ARCHITECT'S SUPPLEMENTAL INSTRUCTIONS

PROJECT:	The Reserves at South Lake New Apartment Complex Grinnell, IA	Report No.	Three (3)
OWNER:	OPG South Lake Partners, LLC Dan Maximuk 234 N. Santa Fe Ave, Suite A Salina, KS 67401	Date	January 18, 2022
CONTRACTOR:	MCP Group 3501 SW Fairlawn Rd. Topeka, KS 66614	Architect's Proj No.	20-3118
		Contract For:	General Construction Mechanical, Electrical

IFA Plan Review

A APARTMENT BLDG. A
FIRST FLOOR PLAN
1/8"=1'-0"

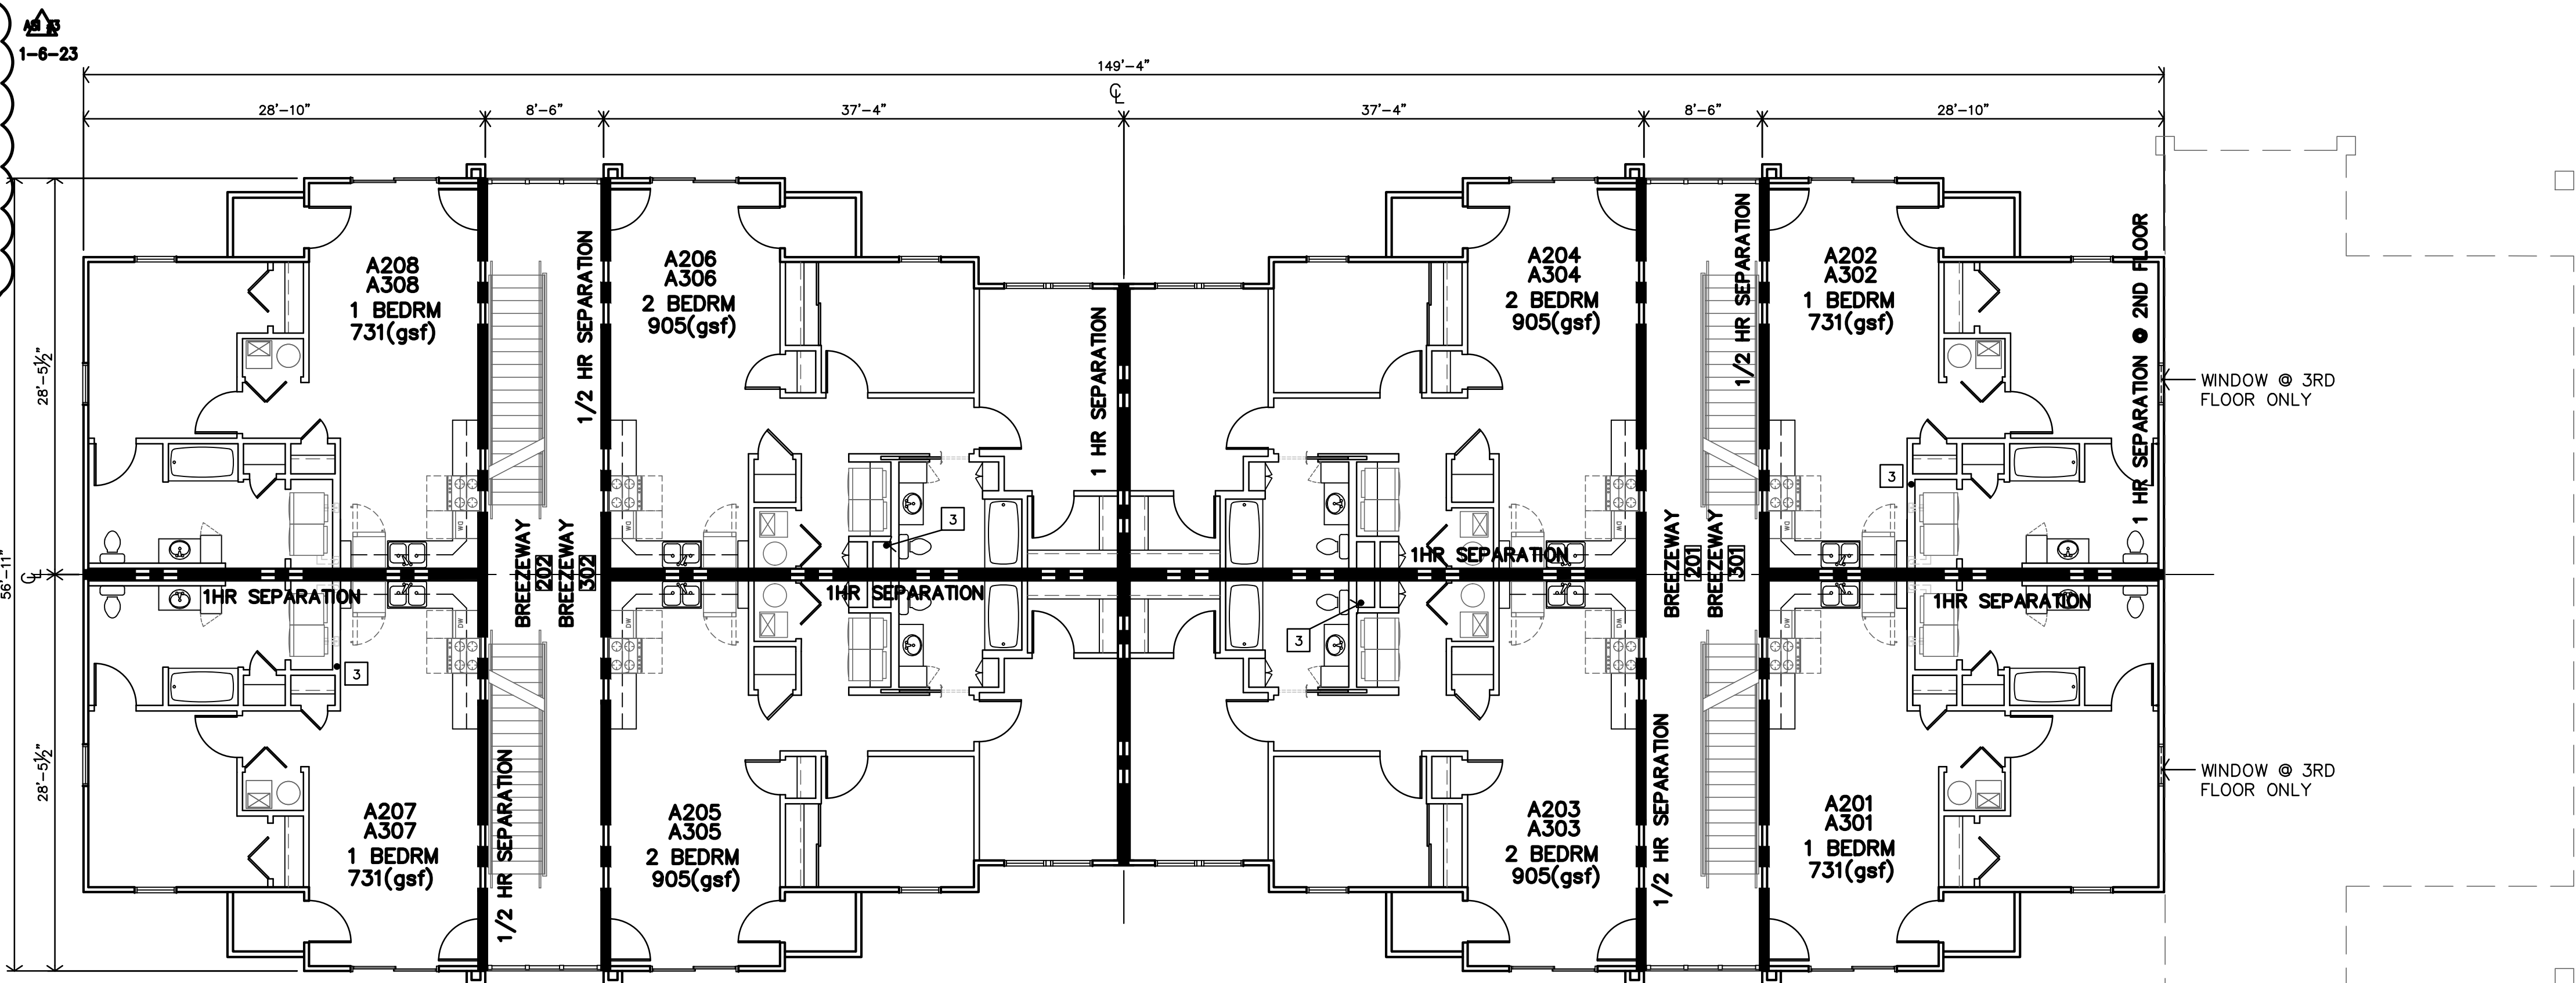
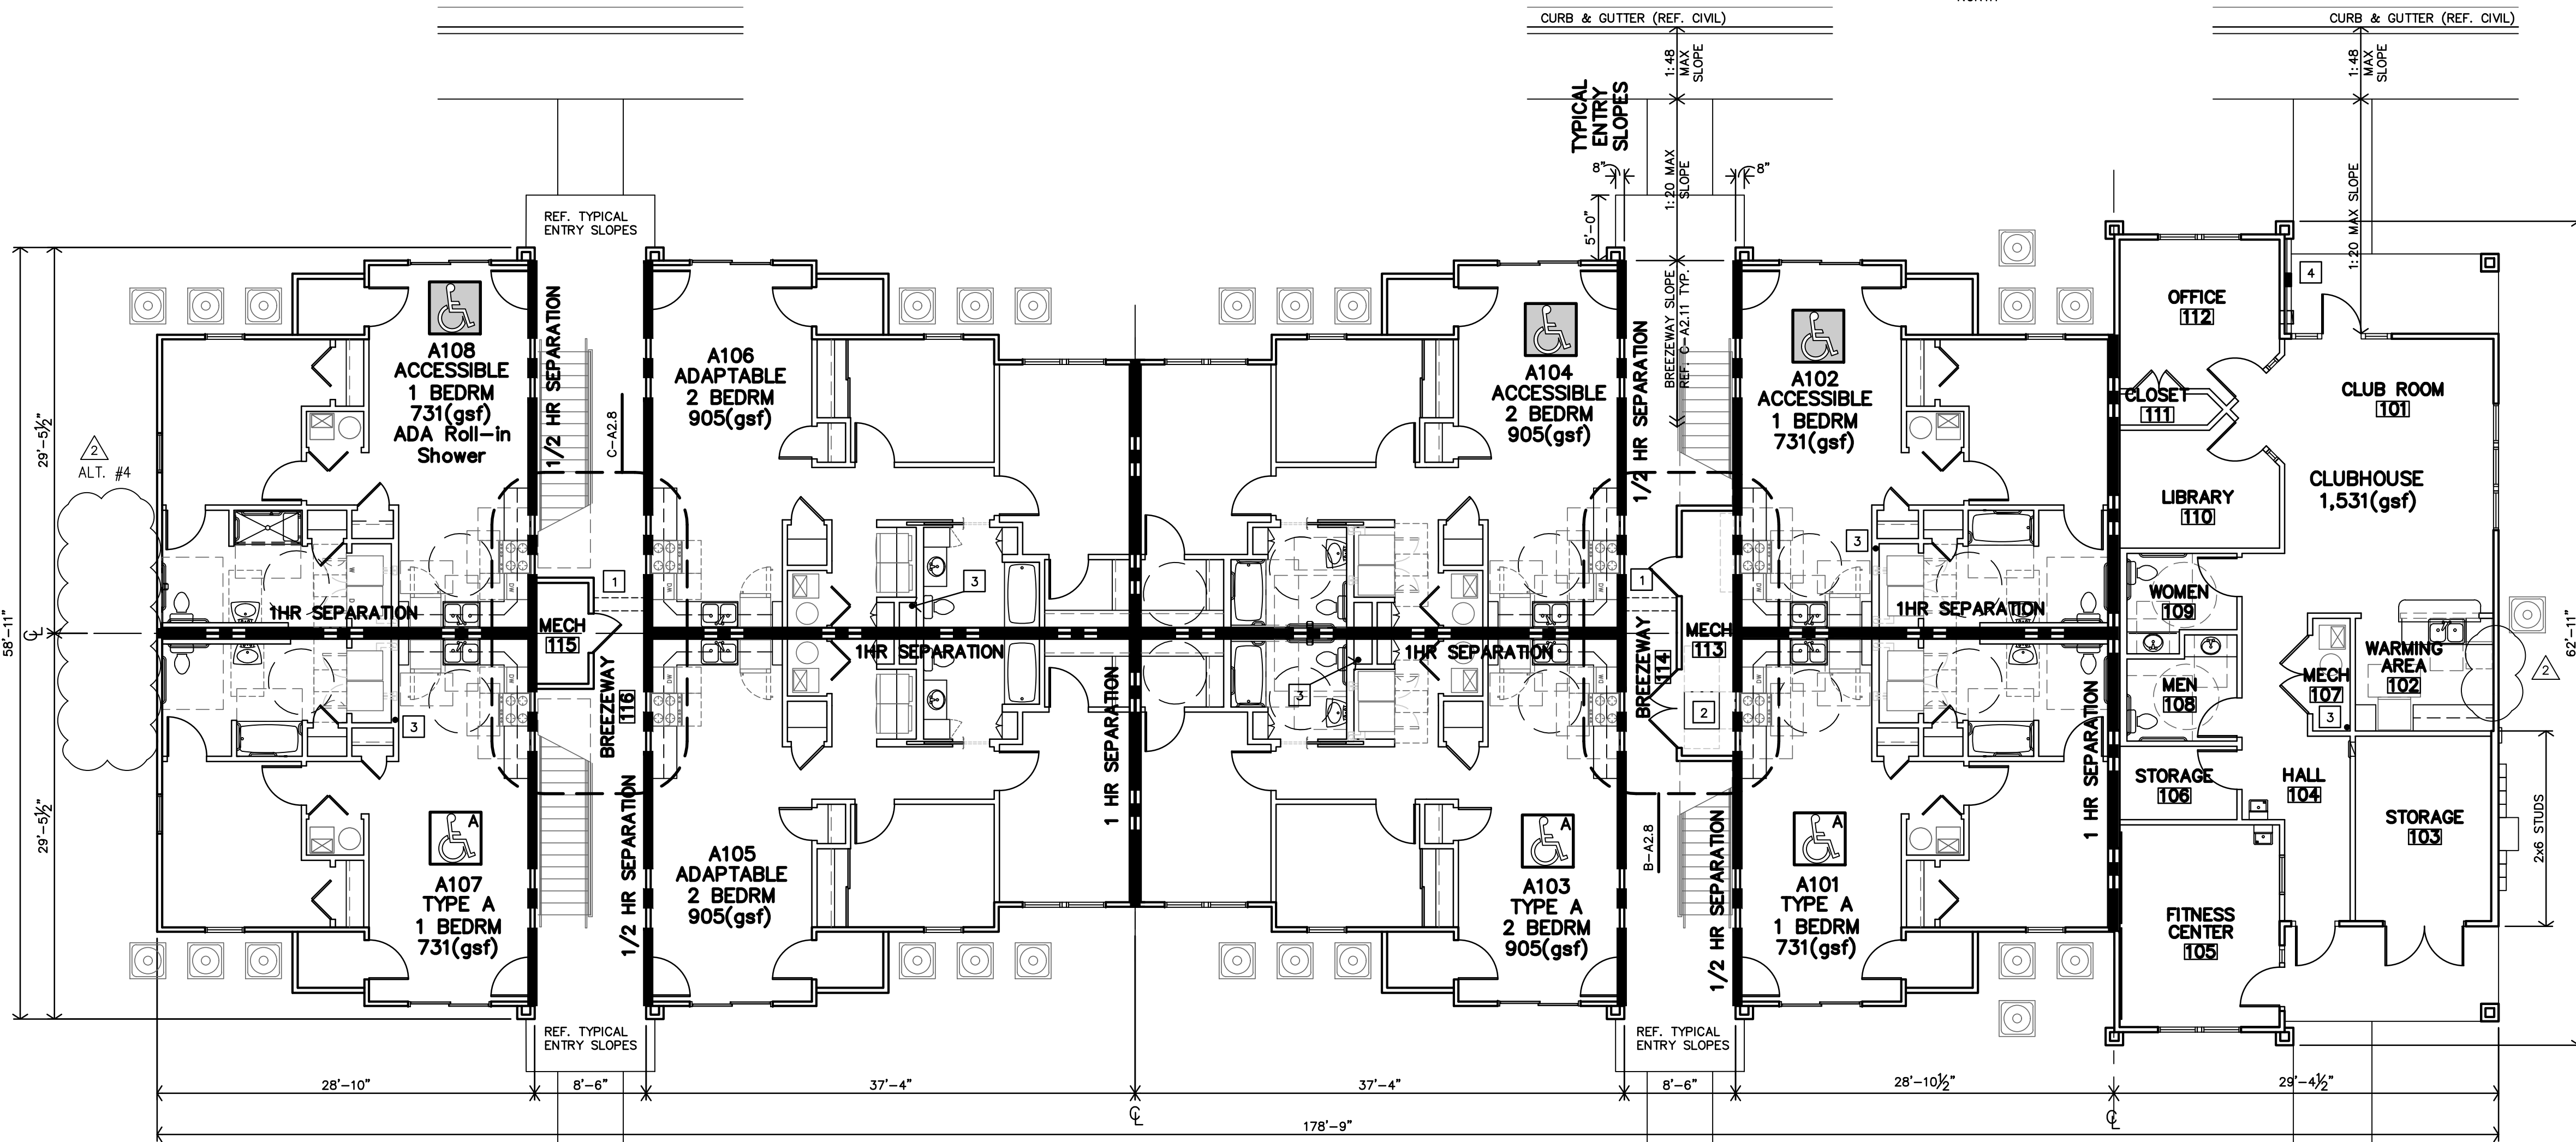
- iv. Sheet A2.10 – Apartment Building A Summary has been corrected
 - v. Sheet A2.11 – Apartment Building B Summary has been corrected
 - vi. Sheets A3.1-A3.3 – notes have been changed to read “hardi-panel siding” in lieu of composite siding

5. On A2.11 and A2.10 the building summaries are flipped, summary for A should be for B and vice versa. This has been revised. See attached Sheets A2.10 and A2.11

A3.1

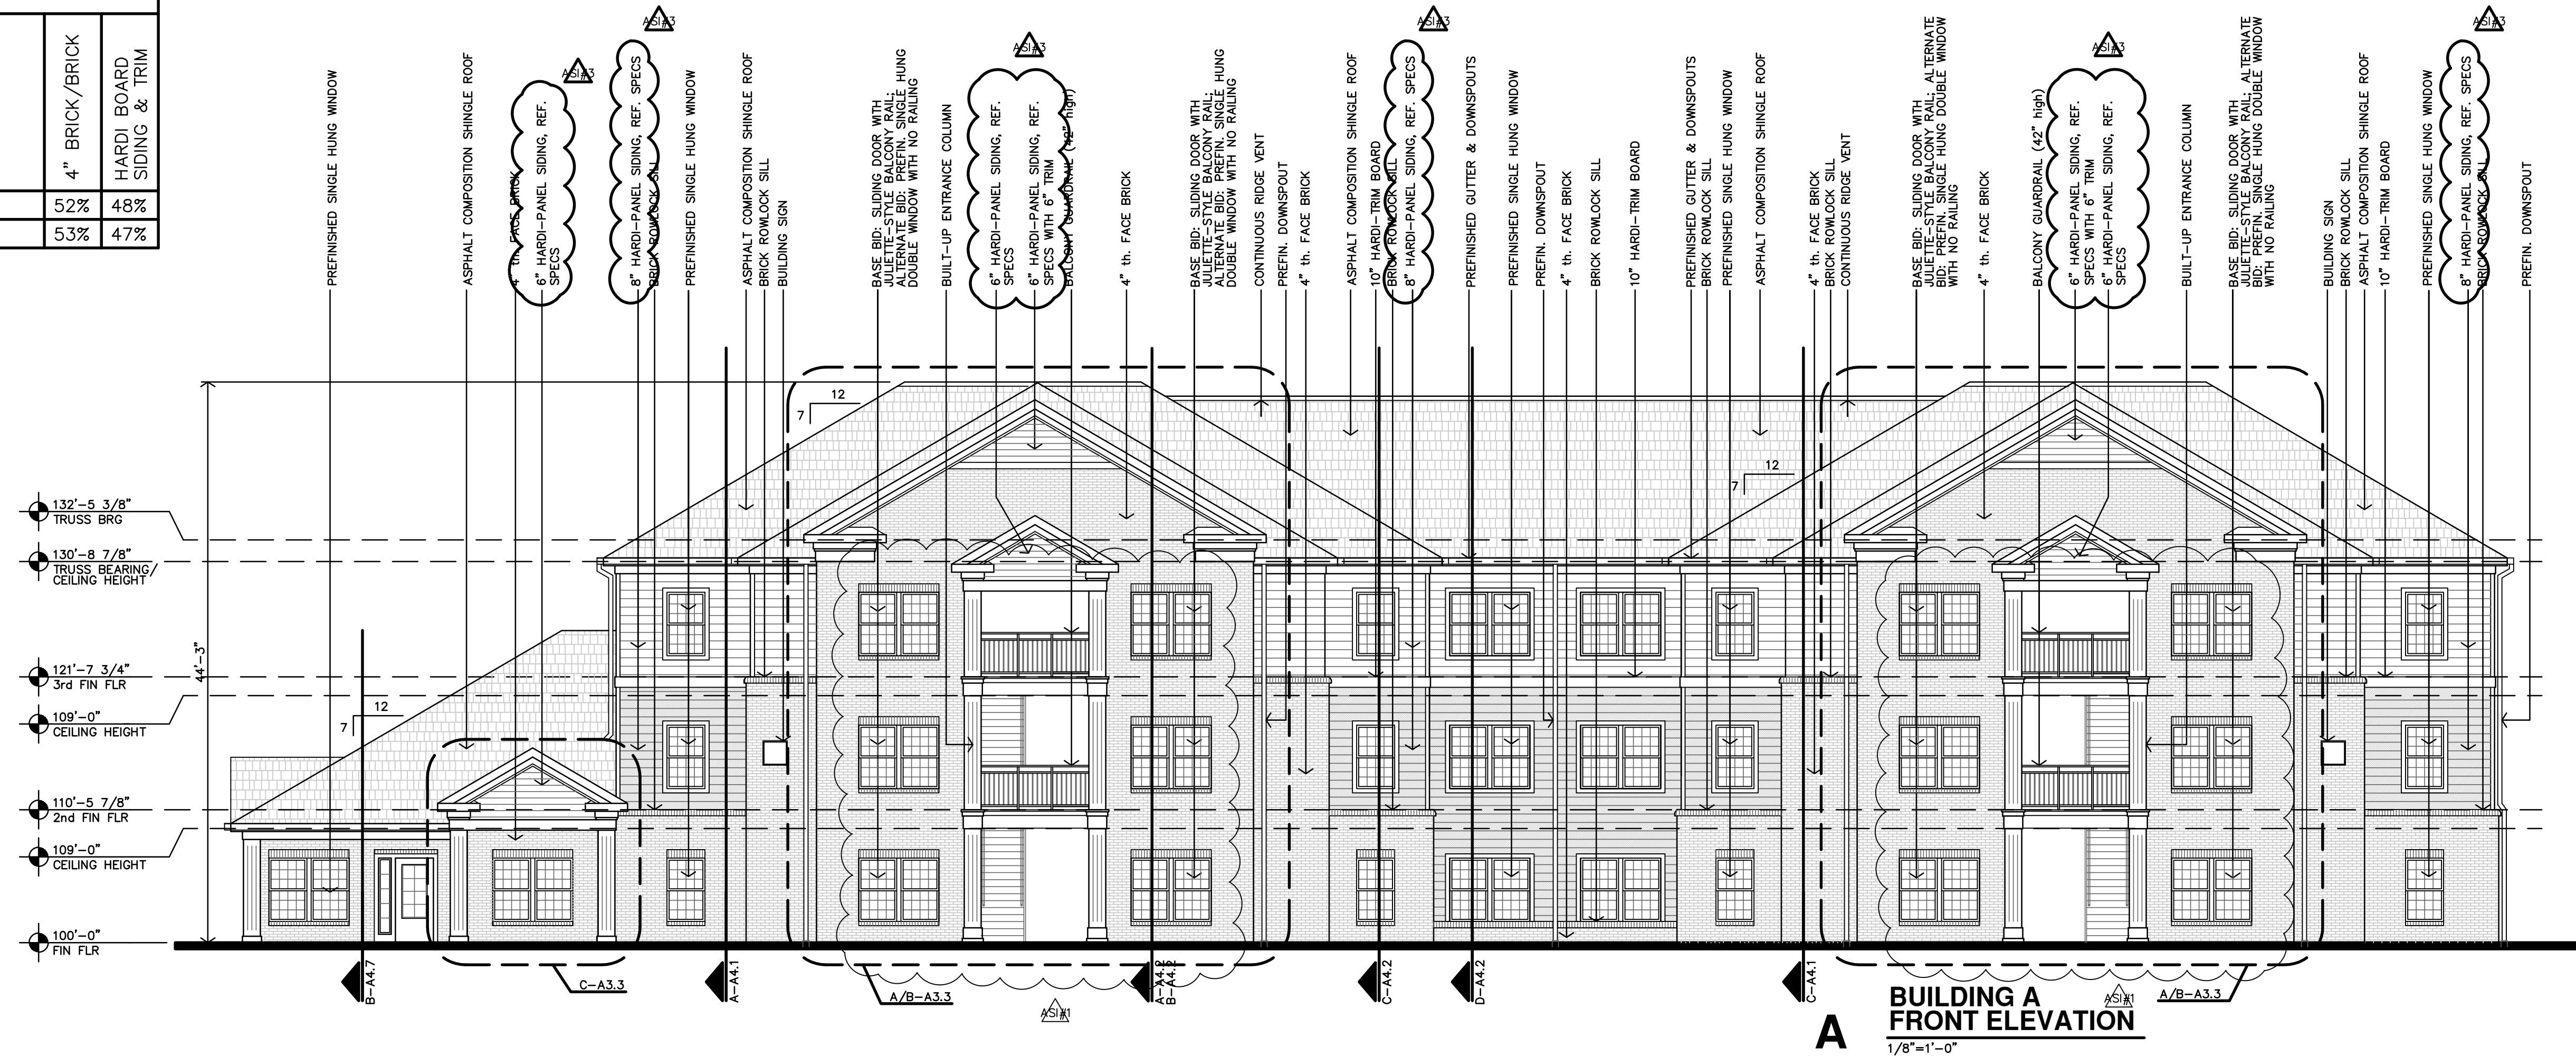
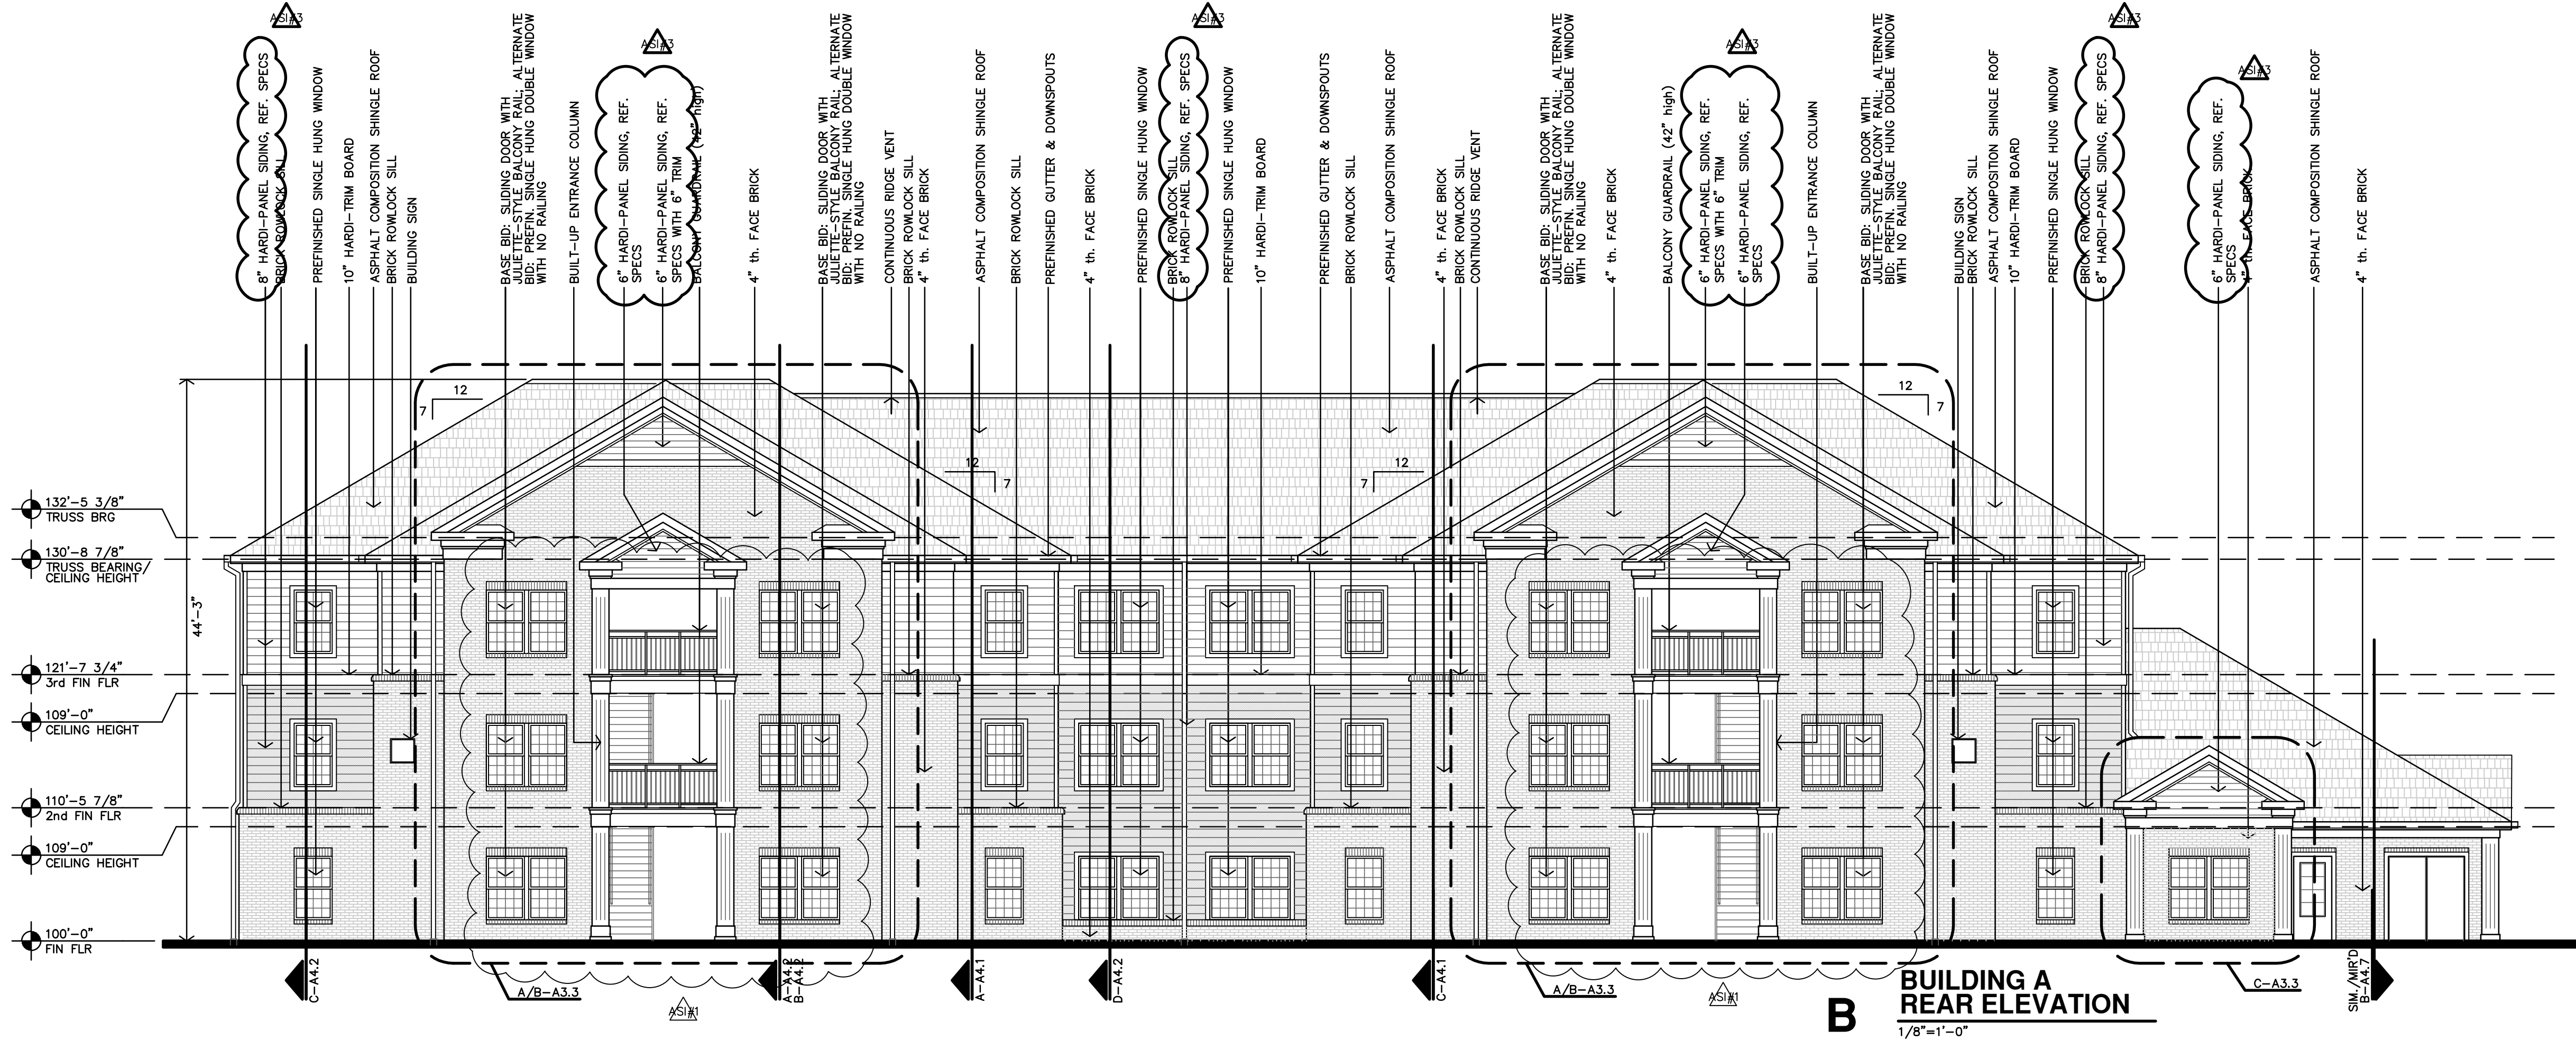
6. Elevations indicate "composite siding". Verify this is the Hardie siding called out in the specs. The only composite siding acceptable for points is Smart Board by LP. Specifications indicate that James Hardie Fiber-Cement Siding shall be used. Elevations have been revised to read "Hardi-panel" in lieu of composite siding. Reference attached specification and Sheets.
